S E R V I C E N O T E

16555A Deep Memory Logic Analyzer Module

Master/Expander operation improvement

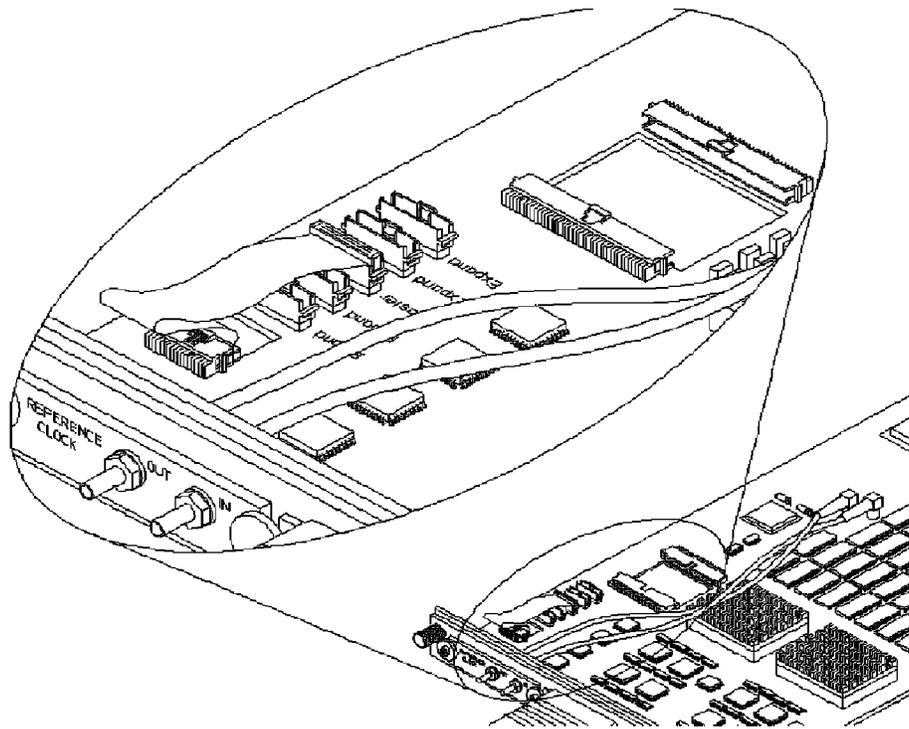
Identify a suspect board by observing the number of expander board connectors on the circuit board as shown in the following figure.

If five connectors are present (J4-J8), then the board requires replacement. Order a replacement board using the 16555-66503 part number. Follow the procedures in the 16555A service manual to perform the replacement. The replacement board does not require calibration.

If only three connectors are present (J5-J7) as shown in the following figure, then the board is not to be replaced.

16555A circuit boards that have five master/expander board connectors must be replaced with the updated 16555-66503 board. The updated 16555-66503 board supports a maximum of 1 master and 2 expander boards (three-board multicard configuration) in accordance with revised 16555A specifications.
